ORIGINATION FORM

Proposed Revisions to a Standard Plans Index
(Please provide all information – Incomplete forms will be returned)

Index Number: 521-640
Sheet Number (s): 1
Index Title: Drainage Inlet Openings in Junction Slab - Wall
Coping

LAST REVISION 11/01/17	DESCRIPTION: ← 11/01/19	 FY 2019-20 STANDARD PLANS	DRAINAGE INLET OPENINGS IN JUNCTION SLAB - WALL COPING	INDEX 521-640	SHEET 1 of 1
--------------------------------------	---	----------------------------------	--	------------------	-----------------

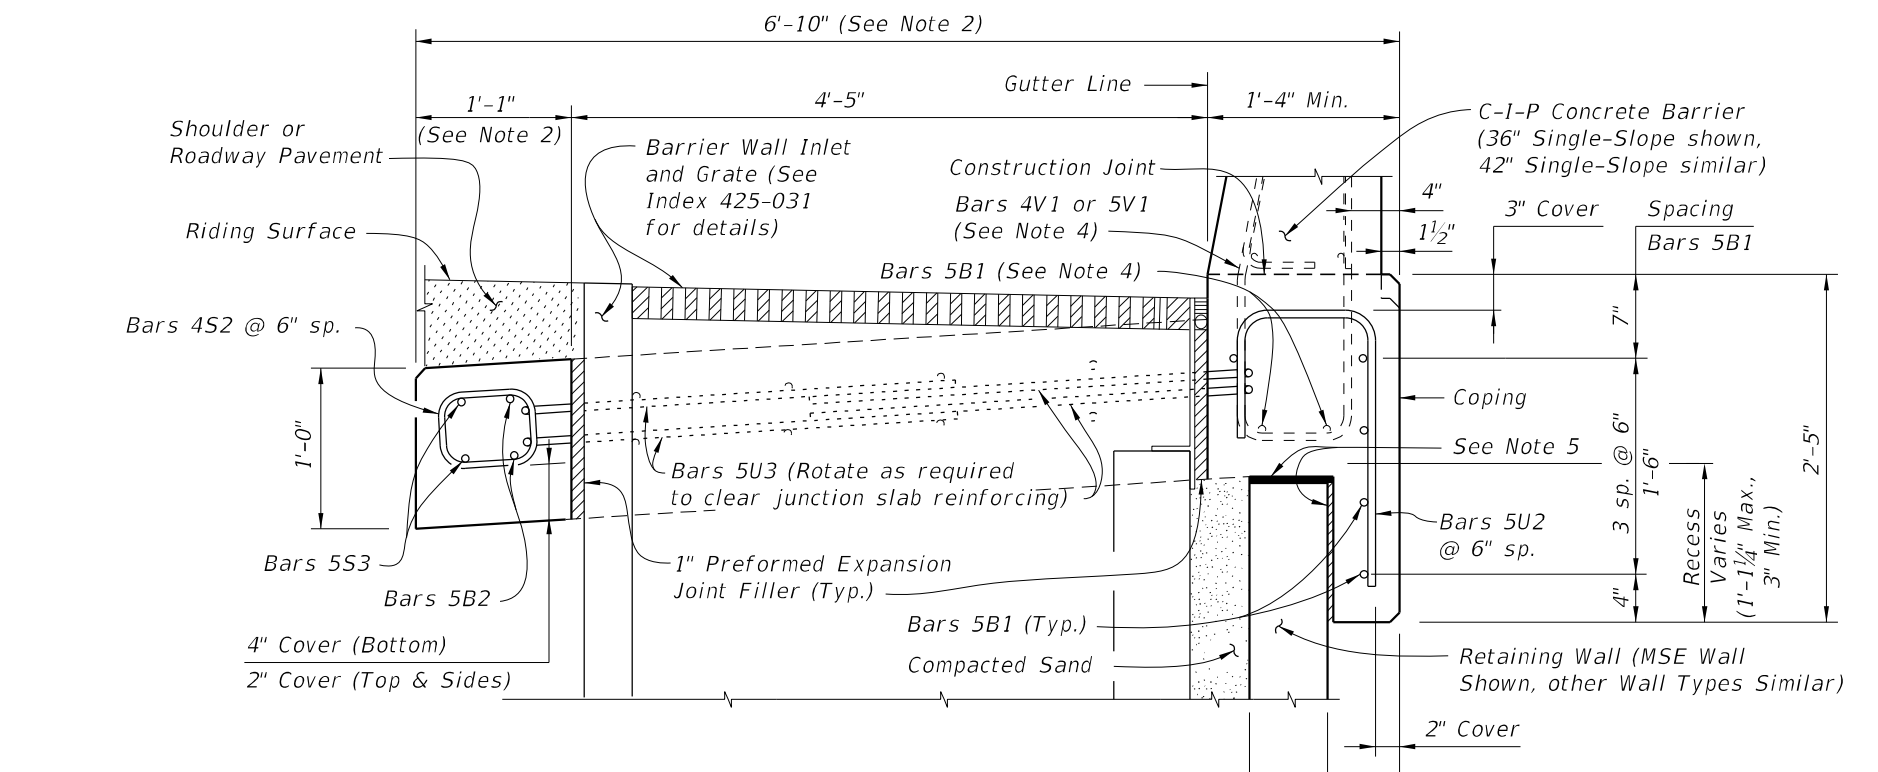
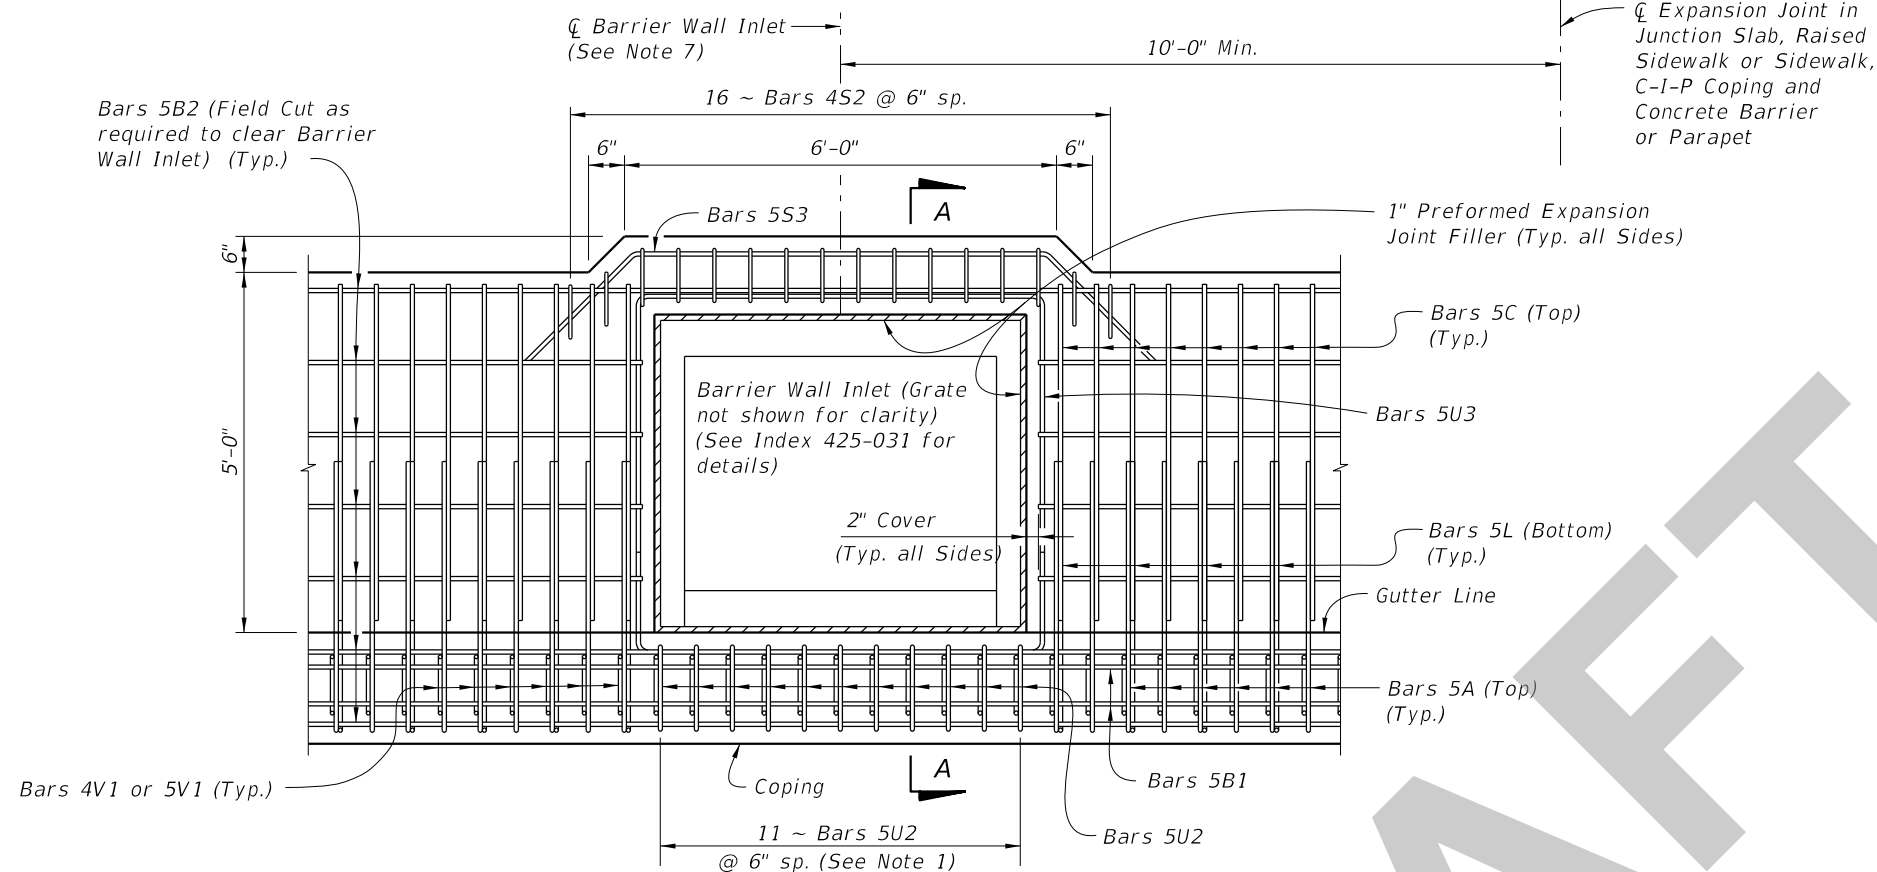
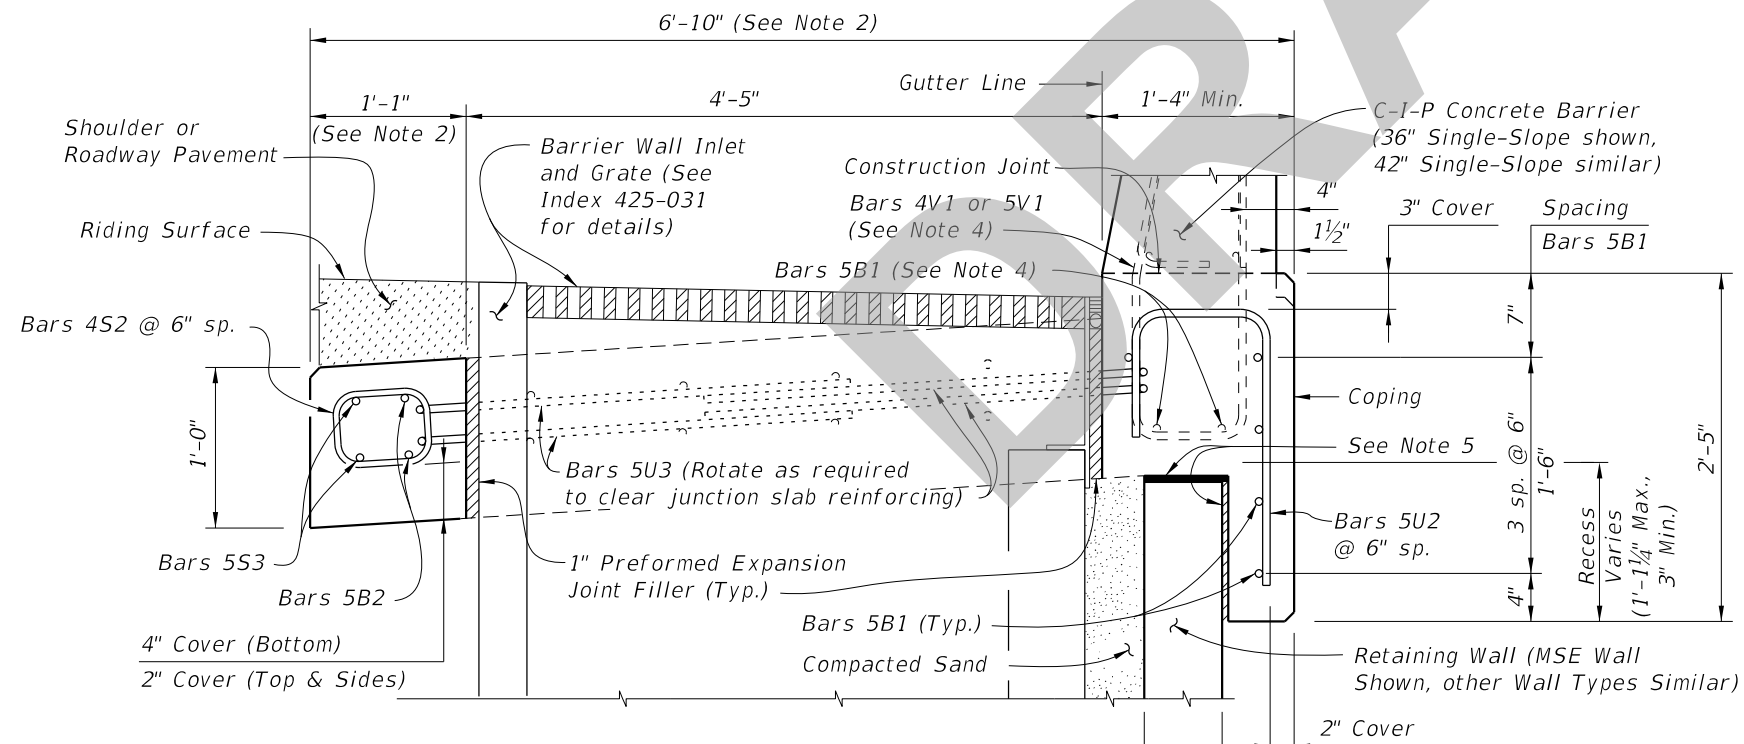
Added Note 7 and renumbered.

Note added to address continuity along the barrier and coping at the drainage inlet openings.

8. **Locate open joints in Barrier Wall and Copping a minimum of 5'-0" from the centerline of the Barrier Wall Inlet.**

- Locate open joints in Barrier Wall and Coping a minimum of 5'-0" from the centerline of the Barrier Wall Inlet.
 - Work this Index with the following as appropriate:
Index 521-610
Index 521-620
Index 521-630
